BCA REPORT

REF SD Design

Hunter River High School

Revision: 3

Figure 5: Block R exposure to new buildings

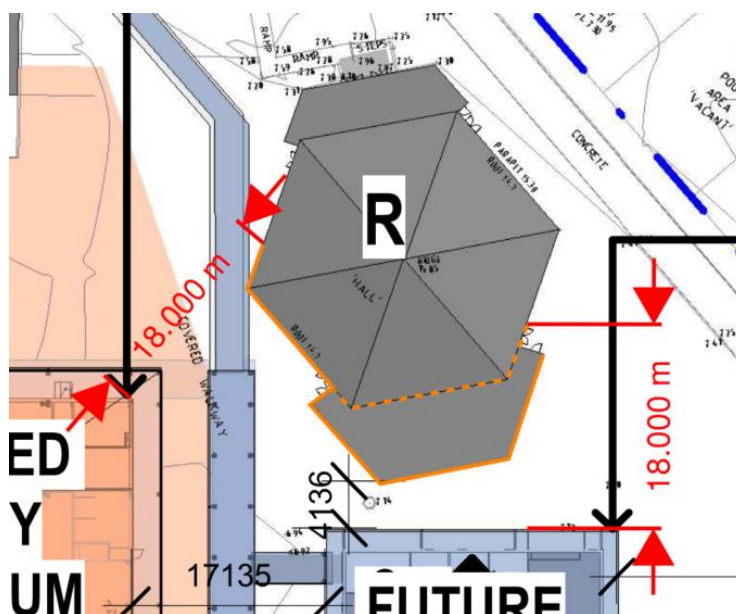
The existing Block R building is required to achieve the minimum fire resistance of building elements as outlined in Table 4 (Type B) of Spec.C1.1 where exposed to a fire source feature such as another building on the same allotment.

Where external columns of Block R do not achieve the minimum required FRL of 120/--/--, it may be rationalised under a fire engineered strategy – this is to be developed with the project fire engineer prior to Crown Certificate stage.

Figure 6: Typical Example of Proposed Equipment

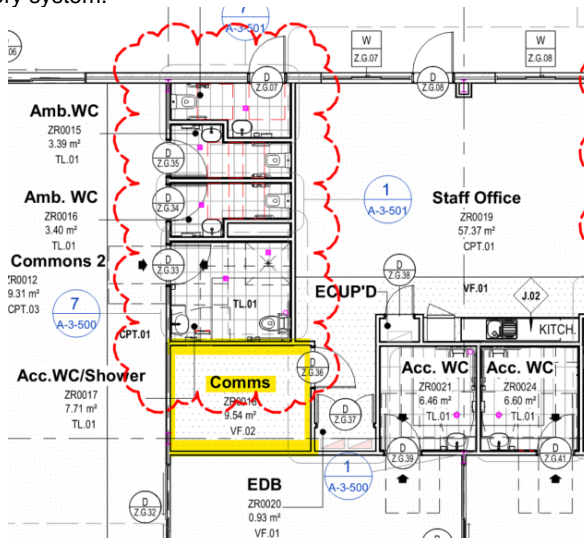
Services consultants are to advise of any proposed equipment within the building requiring separation under this clause. We note that there are a number of comms rooms proposed however it is not clear whether there is equipment proposed within these rooms which would require separation i.e. battery system.

The type of equipment proposed, and any required fire separation where required is to be confirmed prior to Crown Certificate stage.

Figure 7: External Walls within 6m.

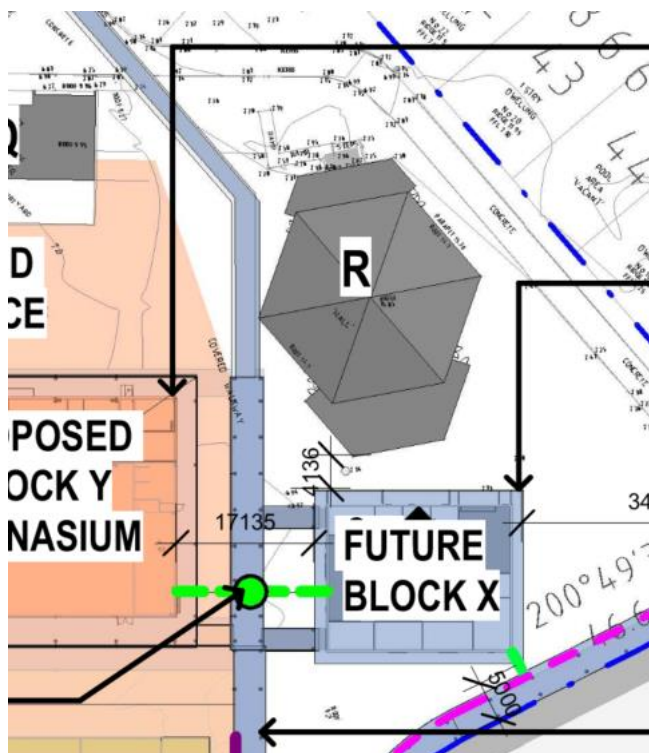
As Block R is of Type B construction and the external walls are confirmed as being load-bearing requiring an FRL, therefore openings in parts of the external wall that are within 6m of Block X are to be addressed under a fire engineered strategy where not protected in accordance with C3.4.

Figure 9: Block X – Required Exits

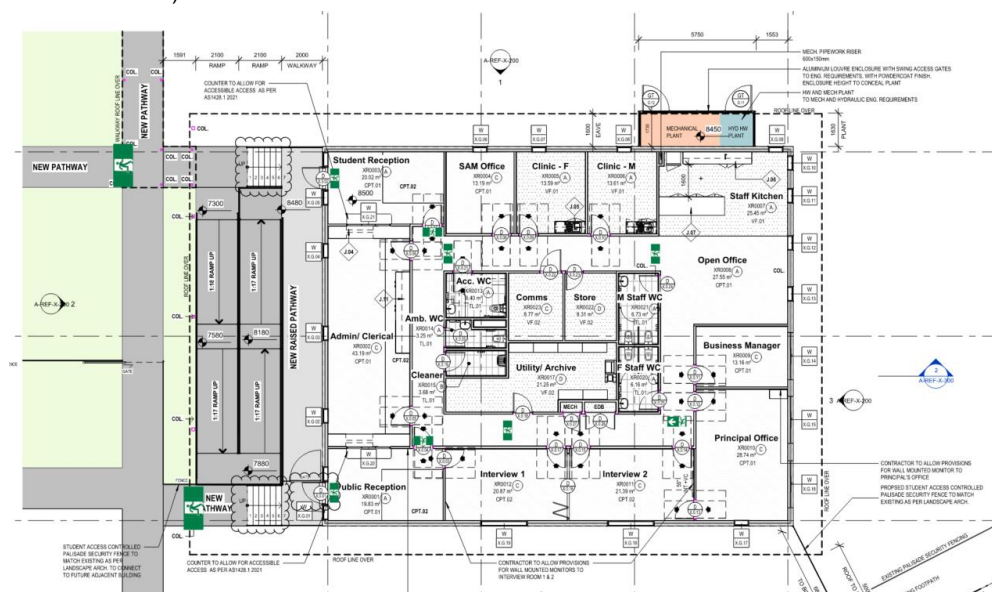
The required exit from each building particularly where a large covered area adjoins the space will be the point at which open space is reached which is relevant having regards to travel distance

Note: For the purpose of assessing travel distances under D1.4 and D1.5 of the BCA it has been assumed that open space will readily be available adjacent to the egress points noted in the figure above which needs to be coordinated with the projects landscape architect – final locations of the external egress paths around the buildings will need to be confirmed, with consideration of reaching open space connected to the road without passing under covered walkways or the like.

Figure 11: Paths of travel to the road from open space

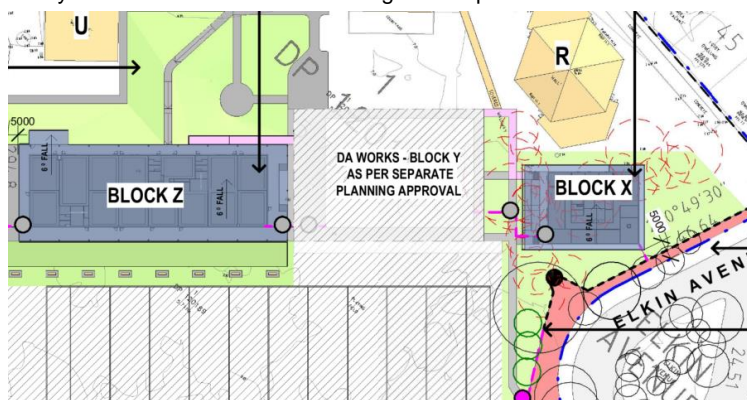
The current egress strategy necessitates passing under linkways after discharging from buildings. This does not comply in respect to D1.10.

The discharge from required exits to the road is to be confirmed, based on the positioning the proposed buildings occupants may be required to pass back under structures or awnings, where apparent this may be rationalised under a fire engineered performance solution.

Where the path of travel to the road from open space is not open to the sky for its length, necessitating passing back under covered areas such as awnings/linkways or the like before reaching the public road this is to be addressed by way of a Fire Engineered Strategy.

Figure 13: Proposed Internal and Boundary Gates

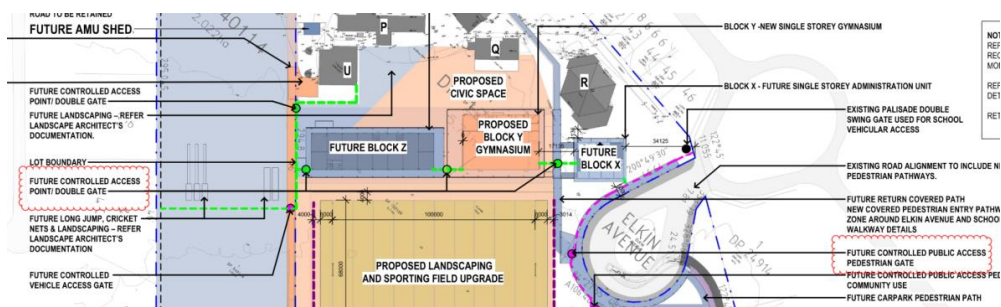
Any proposed lockable gates or the like located in the path of travel are to be addressed under a fire engineering strategy, with consideration of any emergency evacuation strategy proposed by the school – this may include flood refuge areas due to the flood planning levels.

Figure 14: Block X – Ambulant WC

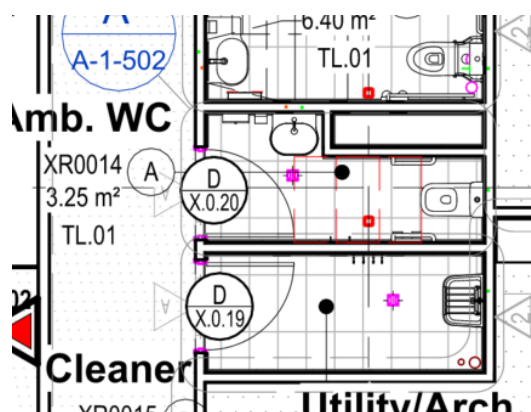
Where an unisex ambulant sanitary facility is provided at an accessible bank of toilets, in lieu of separate male and female ambulant facilities being provided, this is to be addressed under a Performance Solution by the project access consultant – this is apparent in Block X (refer to below).

Additionally, where ambulant facilities are to be nominated as unisex, such as where two (2) ambulant facilities are proposed in Block Z, this is to be addressed via a Performance Solution in lieu of satisfy the requirements of the deemed-to-satisfy provisions.

Figure 16: Block Z – Sanitary facilities

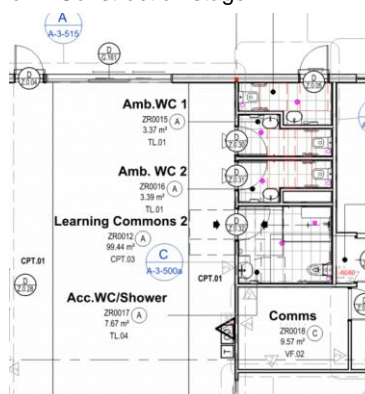
Where proposed to be addressed under a Performance Solution, a suitably qualified mechanical consultant is to provide expert judgement and/or a comparative assessment to determine the adjacent spaces are not adversely affected by objectionable odours – this may be achieved with suitable exhaust rates being provided to the mechanical exhaust system and self-closing doorways between the relevant parts.

Details are to be provided at Crown Construction stage.
